CITY OF GAHANNA, FRANKLIN COUNTY, OHIO DESIGN REVIEW PLAN FOR THE MARKET AT ROGER'S CORNERS PARKING EXPANSION 2023

Re: Roger's Market Planning Commission Materials

Subject: Project 1379-1391 E Johnstown Rd Design Review/C of A
Response Letter

In response to the comments received from City of Gahanna on February 22, 2023, the plans have been modified as described herein.

CITY OF GAHANNA, FRANKLIN COUNTY, OHIO
DESIGN REVIEW PLAN
FOR
THE MARKET AT ROGERS' CORNERS
LANDSCAPE DETAILS

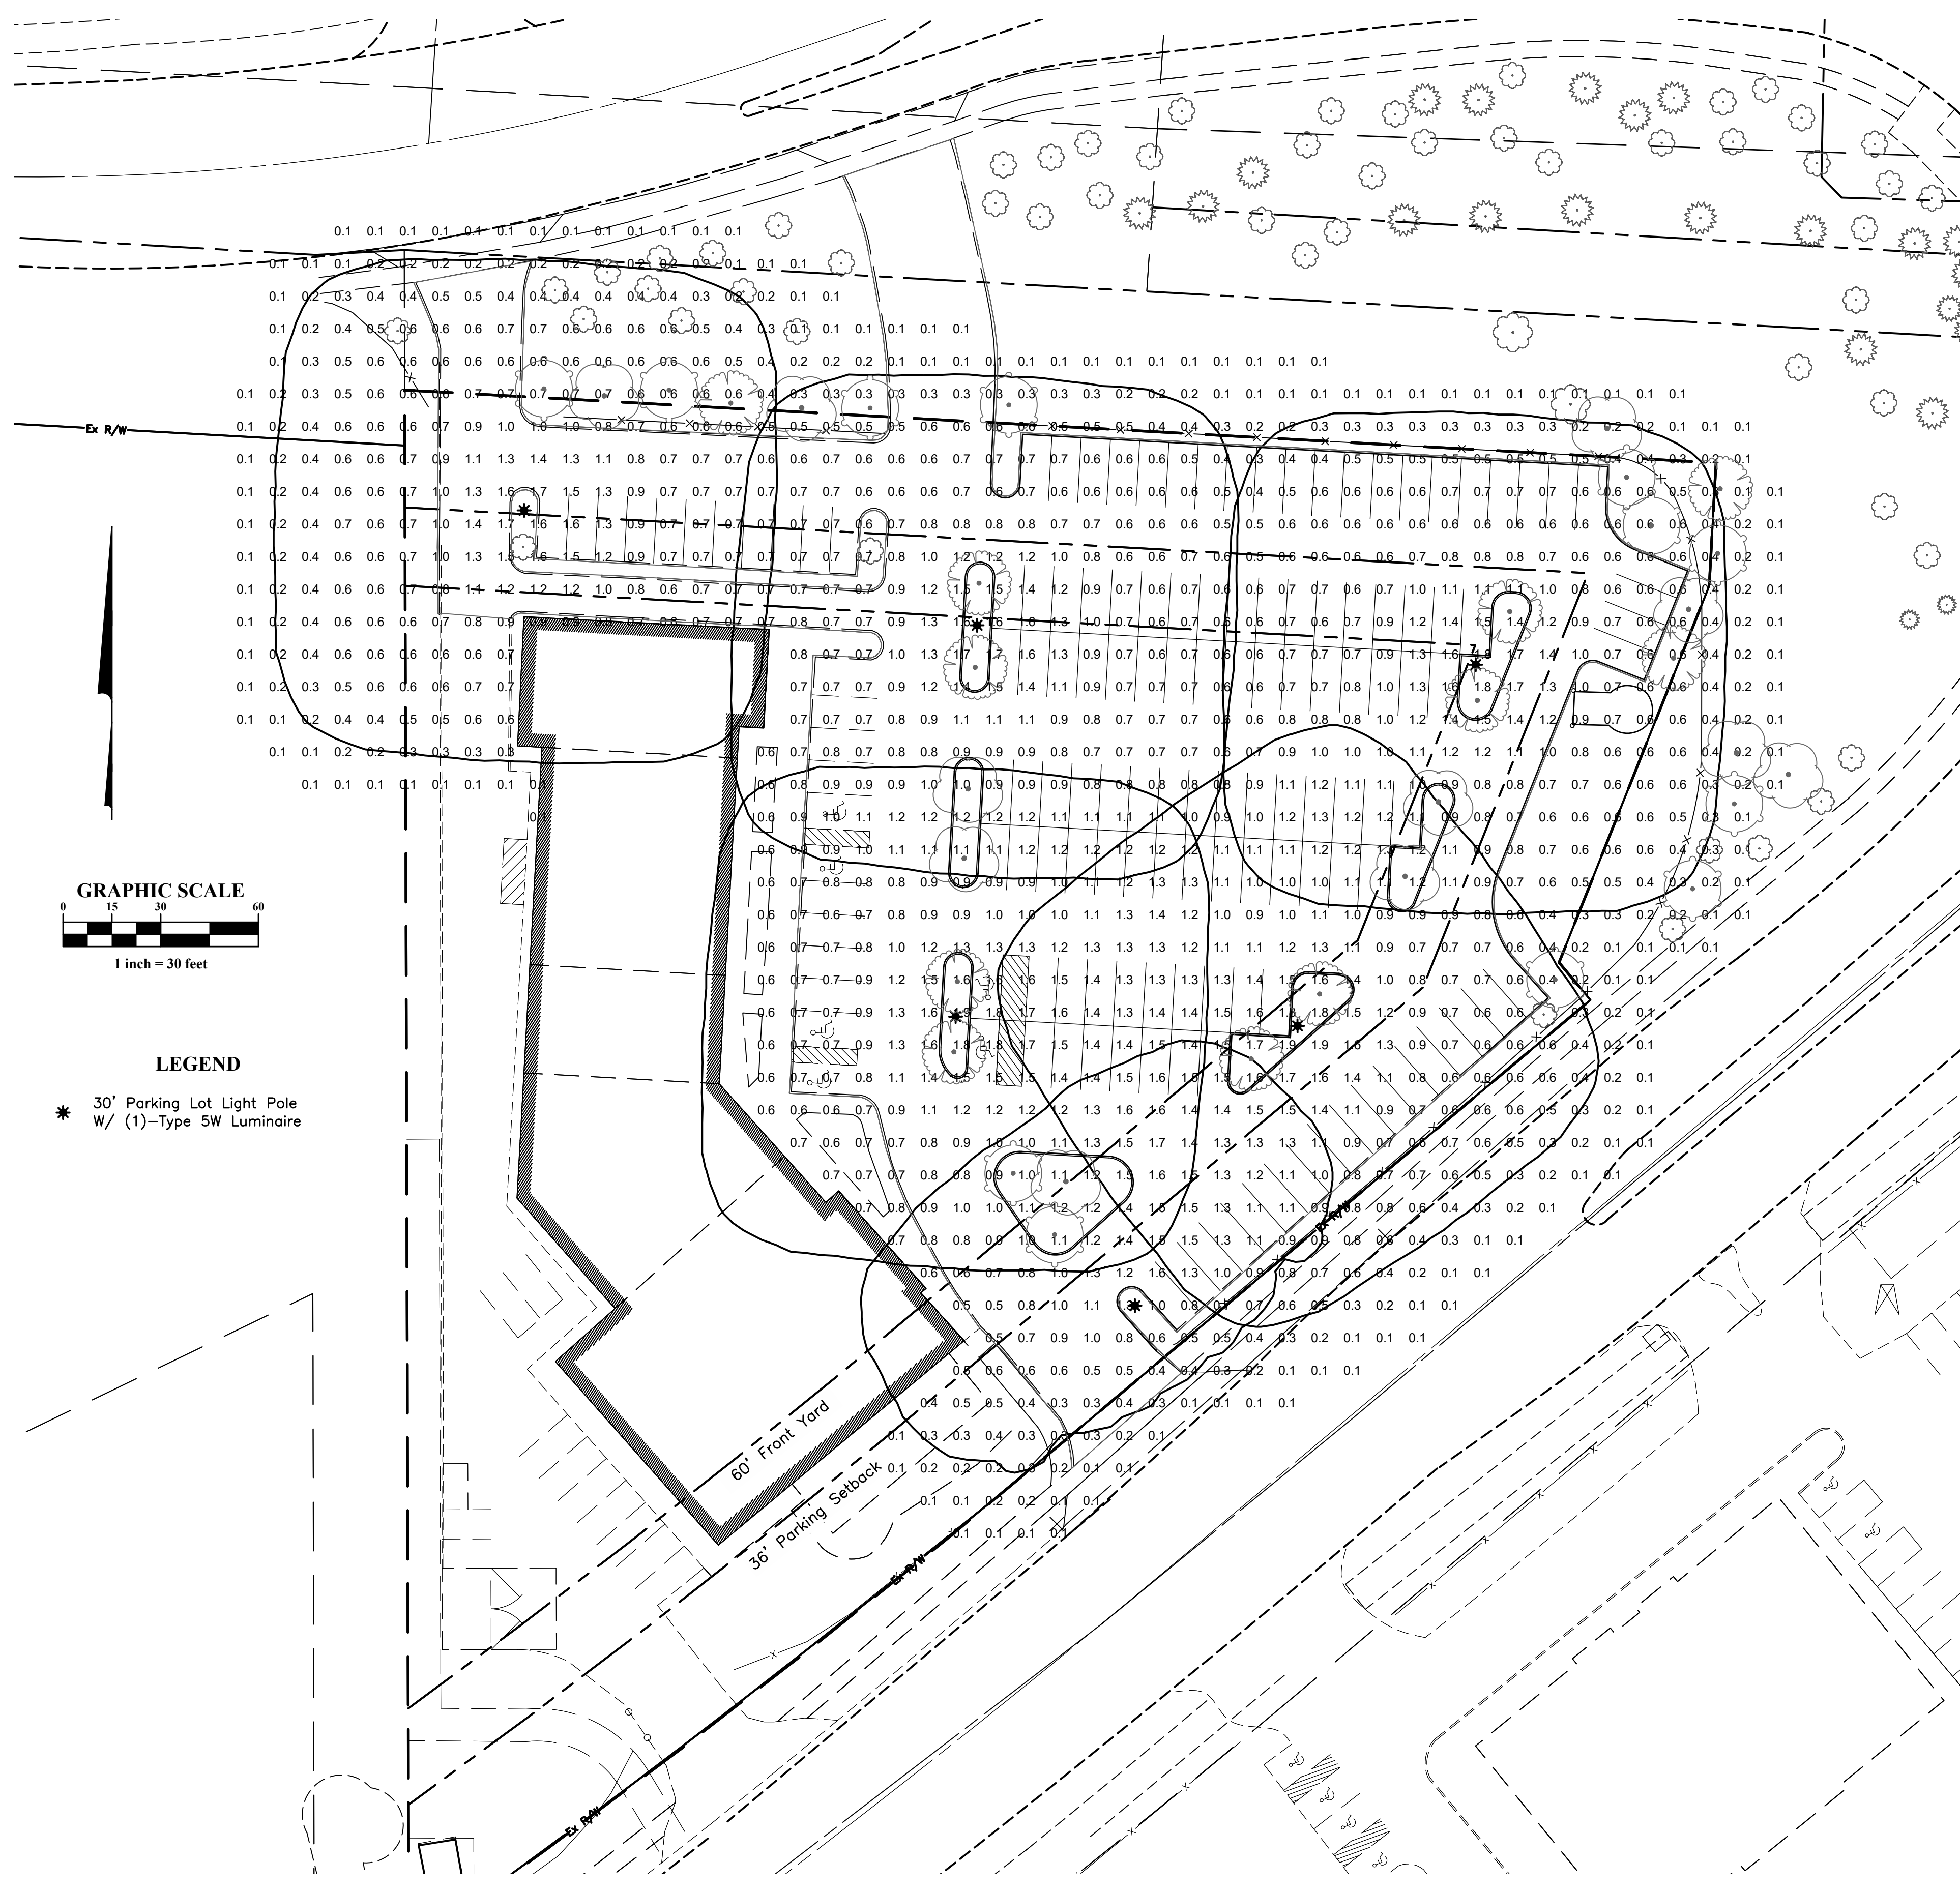
13. Sheet 5 depicts a 54" fence in the front yard(s). Chapter 1171.03(f) permits a maximum fence height of 42". A variance will be required if the fence is located in the front yard. Please revise the site plan to clearly depict fence location. Please revise the variance application as necessary.

4. Sheet 5 depicts a 54" fence in the front yard(s). Chapter 1171.03(f) permits a maximum fence height of 42". A variance will be required if the fence is located in the front yard. Please revise the site plan to clearly depict fence location. Please revise the variance application as necessary.

Response: Current fence is 54". Variance application has been revised and sent with the submittal package.
